**ADDENDUM NO. 1
TO THE CONTRACT DOCUMENTS
FOR THE CONSTRUCTION OF
SOUTHWEST AQUEDUCT REACH 2 PROJECT**

Date: February 6, 2025

The following changes, additions, and/or deletions are hereby made a part of the Contract Documents for the Construction of the Southwest Aqueduct Reach 2 Project, dated January 2025 as fully and completely as if the same were fully set forth therein.

CATHODIC PROTECTION
JA-2 TYPE A TEST STATION PLANS
 DATE: JANUARY 2025
 PROJECT NUMBER: 010-23-02

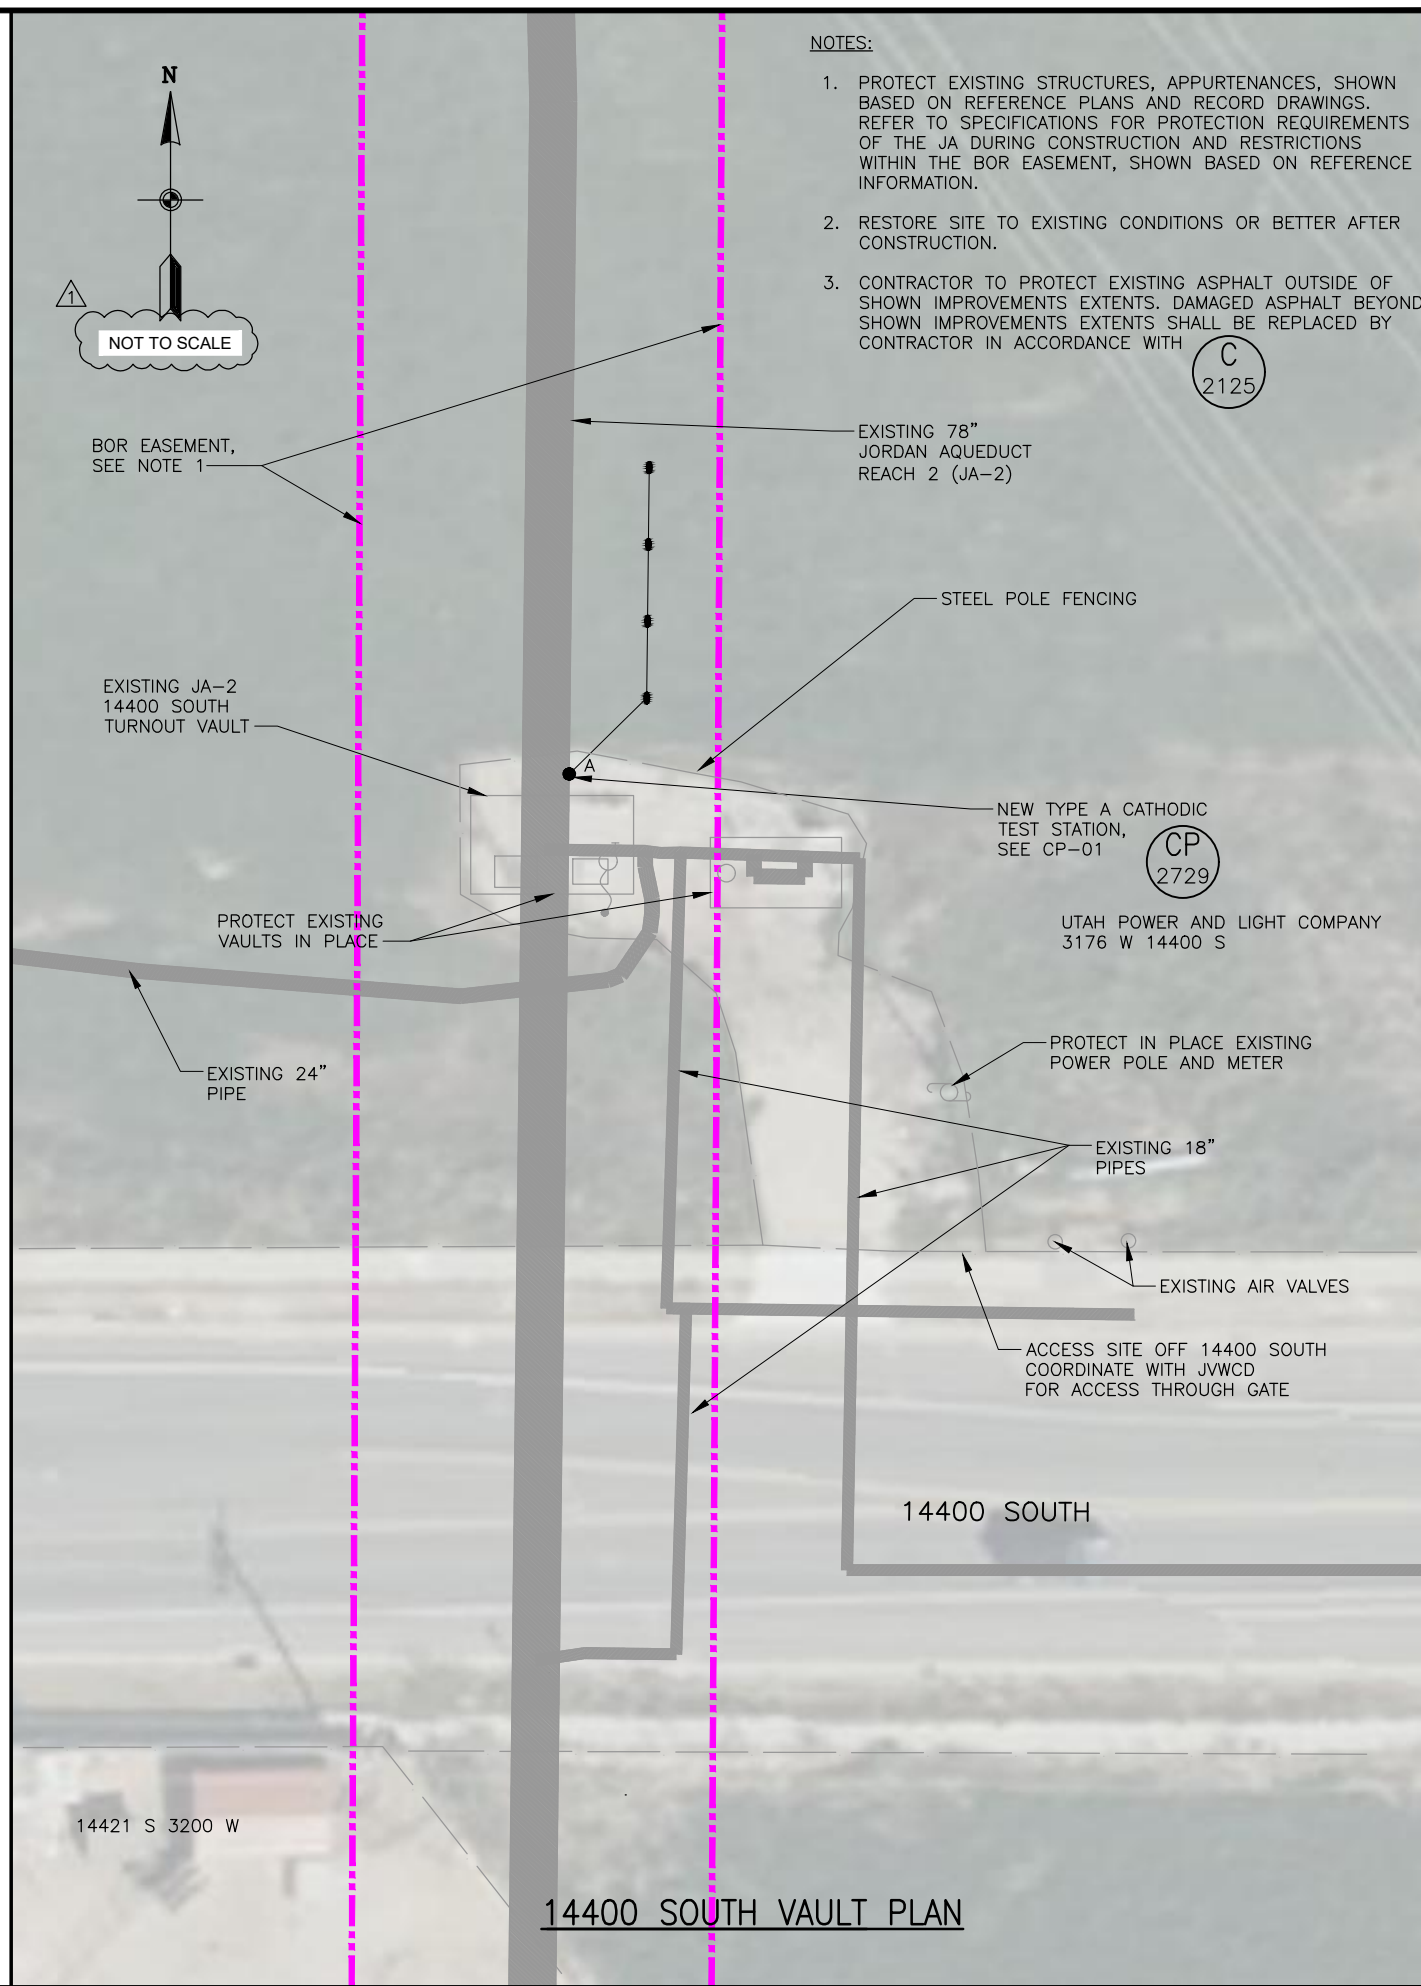
- b. Scales on the two windows are incorrect, DELETE drawing CP-02 and REPLACE with the attached drawing CP-02.
